PORTLAND PUBLIC SCHOOLS – FACILITY ADA ASSESSMENT

Sunnyside School K-8
August 31, 2009

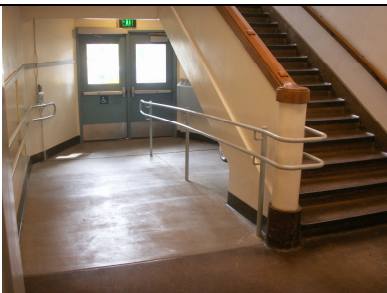
Parking	<p>No on-site parking is available for this school.</p> <p>A 38 ft double length ADA on-street parking space is marked and signed at SE 36th Ave at the corner of SE Salmon St. There is an adjacent compliant corner curbcut for access to the sidewalk.</p> <p>Add directional signage to indicate direction of fully accessible building entry.</p>	
East Entry	<p>Existing accessible entry is closest to on-street parking. Provide directional signage to accessible south entry.</p>	
South Building Entry	<p>The south entry has a compliant ramp with double handrails leading up from the sidewalk to the raised doorway. This is the closest building entry to the office and is marked by a community seating gazebo at the sidewalk edge.</p> <p>Add directional signage near sidewalk.</p> <p>Provide accessible entry sign.</p>
